N9000A-01

N O T E

Agilent N9000A CXA Signal Analyzer

Enhance the ESD Protection of RF Front End

Figure 1 Screws on top shield of RF Assembly

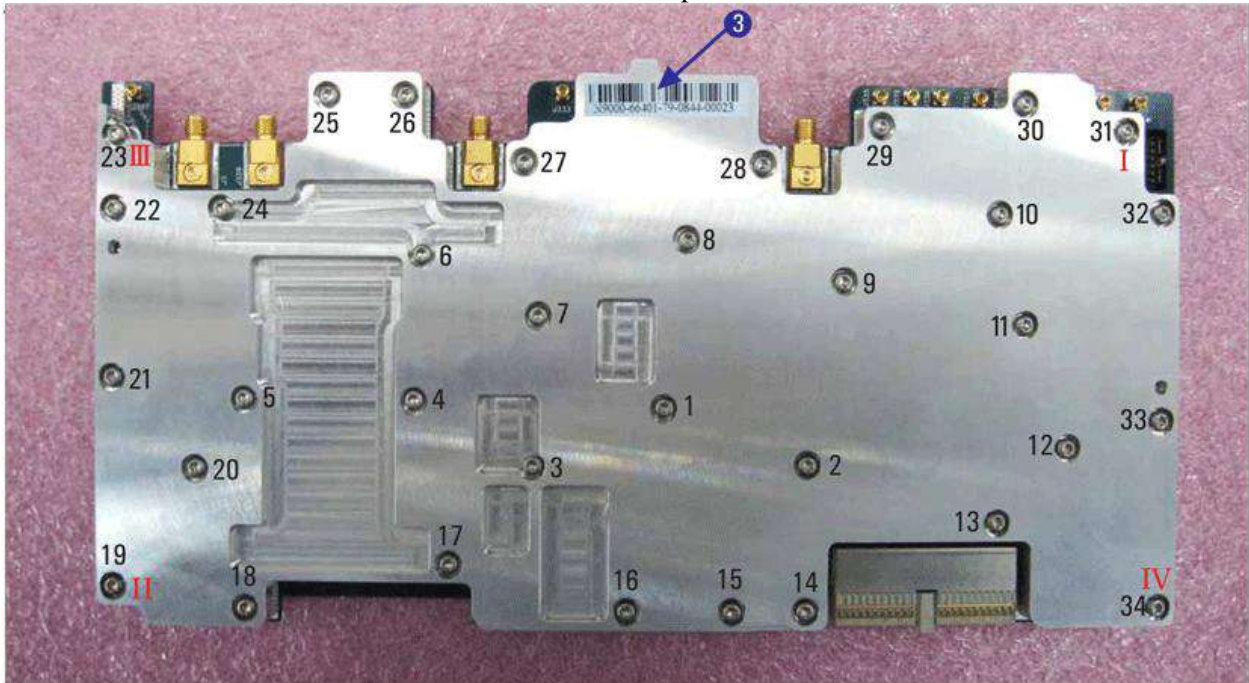
1. Remove the Analyzer's RF Assembly as described in the "Assembly Replacement Procedures, RF Assembly, Removal" in the N9000A CXA Service Guide.
2. Remove the all the 34 screws as shown below on the top shield.

7. Assemble the top shield, bottom shield and gasket onto the RF board.
8. Refer to figure 1, secure 4 corner of the RF board with screws following the sequence. Torque screws hand tight.
9. Secure the RF top shield with other 30 screws and then torque all the 34 screws to 9 in-lbs.
10. Re-install the RF Assembly as described in the "Assembly Replacement Procedures, RF Assembly, Replacement" in the N9000A CXA Service Guide.
11. Perform the Adjustments and Performance Verification as described in "RF Assembly Changed/Repaired, Post Repair Testing Requirements" in N9000A CXA Service Guide.

Figure 2 Bottom side of the RF board

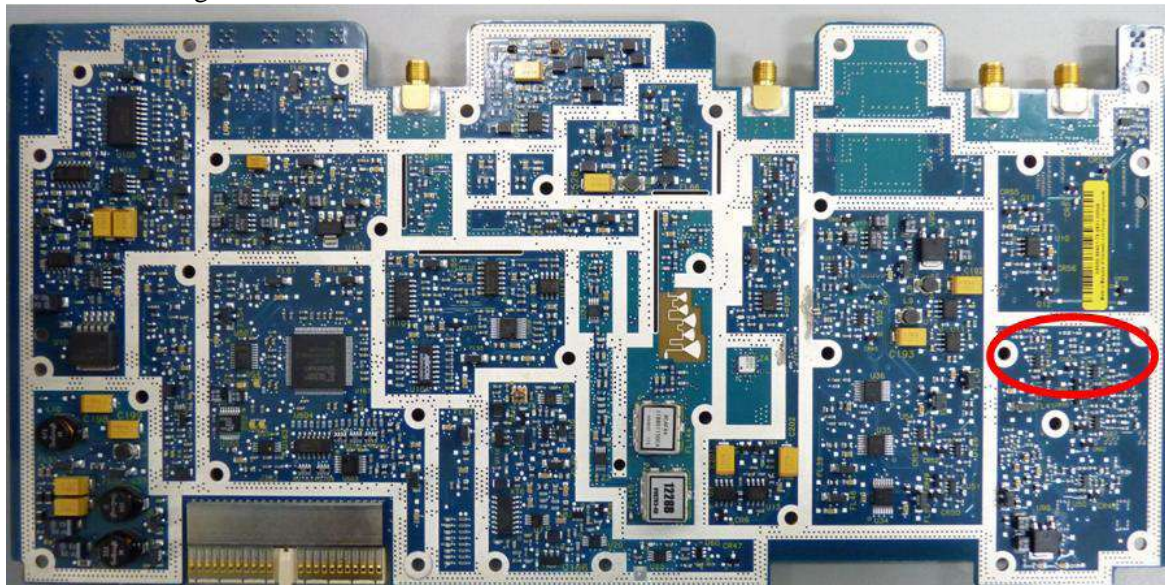
4. Refer to figure 2 and 3 to locate the R71, R72, R73, R74, C81, C82 on the bottom side of RF board.

Figure 3 Location of R71, R72, R73, R74, C81, C82

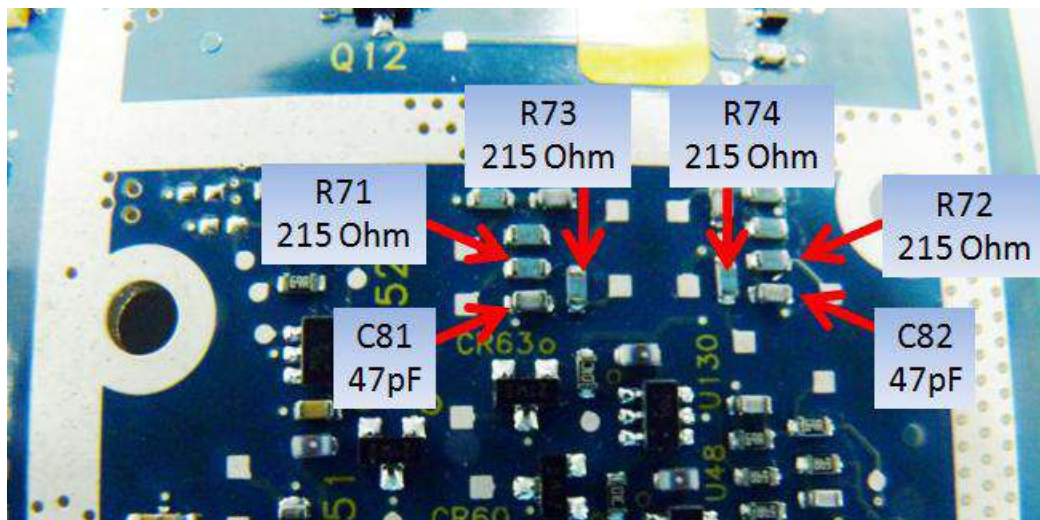
5. Remove R71, R72.

6. Replace R73, R74, C81, C82 each with 0699-3574.
